## Rother Valley Railway Level Crossing – C18 Northbridge Street, Robertsbridge Stage 1 Road Safety Audit

**Rother Valley Railway Level  
Crossing - C18 Northbridge Street,  
Robertsbridge**

Stage 1 Road Safety Audit

RSA1.1

Figure 1 Location of Recommendations

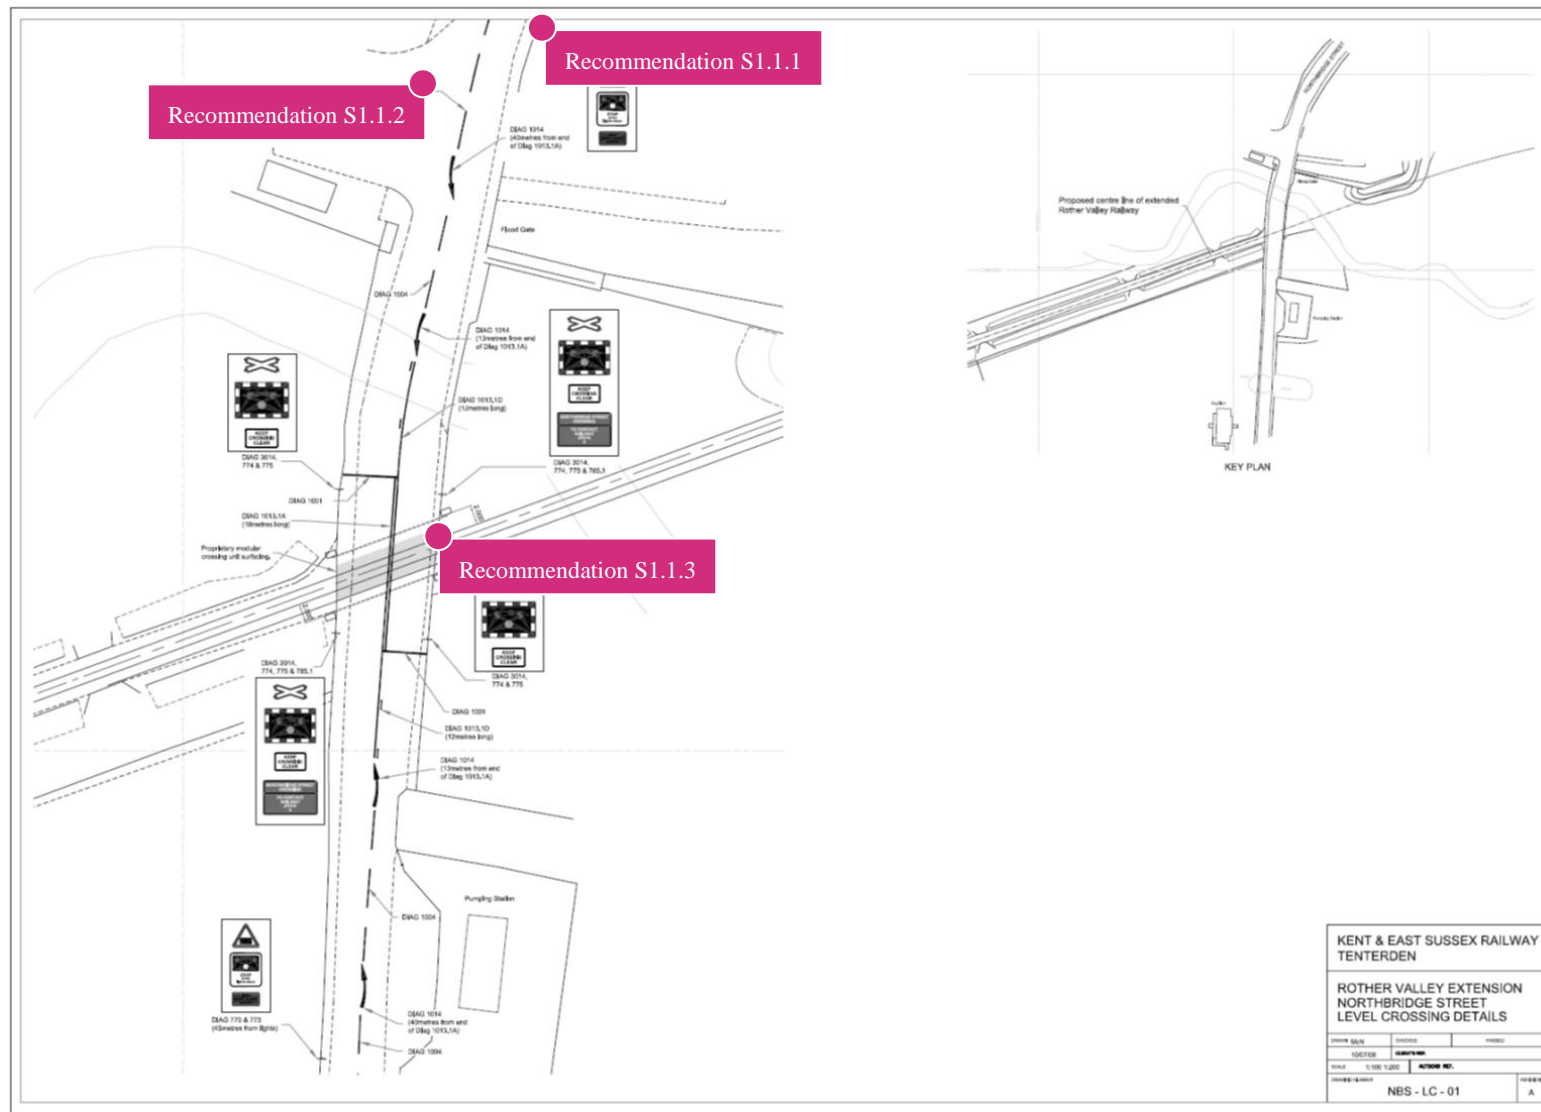
- Location:** Northbridge Street, southbound approach
- Summary:** Limited forward visibility to level crossing leading to shunt type collisions.
- Description:** The approach to the level crossing is situated on a bend in the road

There is a cottage located close to the road limiting drivers' forward visibility on the bend. In the same location there is on-street residents' parking, which requires traffic to cross the carriageway centreline. This could draw drivers' attention away from downstream hazards such as a stationary queue of vehicles at the level crossing, leading to shunt collisions.

- Location:** Northbridge Street, carriageway
- Summary:** Adjacent accesses increase the risk of blocking back at the level crossing.
- Description:** There are a number of accesses close to the proposed level crossing location, not least that of a four hectare industrial development site, which could generate a significant volume of additional traffic movements.

The limited carriageway width and on-street parking could result in traffic waiting on the carriageway by the level crossing and will increase the risk of vehicles queuing over the level crossing, leading to potential vehicle / train conflict.

- Location:** Northbridge Street, footways
- Summary:** Insufficient warning for the visually impaired could lead to pedestrian injuries.
- Description:** Footways are provided along both sides of Northbridge Street in the vicinity of the proposed level crossing.

The visually impaired use tactile warning surfaces to identify hazards ahead. A visually impaired pedestrian could enter the level crossing zone without realising the hazardous nature of the environment, placing them at risk of being trapped by the barriers.

- S1.1.1 Recommendation:** Move the northern-most warning signs to TSRGD Diagrams 770 and 773 to the northern side of the drainage culvert to provide additional advanced warning.
-

- S1.1.2 Recommendation:** Introduce a yellow box marking to TSRGD Diagram 1045 to deter traffic from queuing over the crossing.
-

- SS1.1.3 Recommendation:** Introduce tactile warning surfaces, in line with national guidelines, on each footway approach to the crossing.
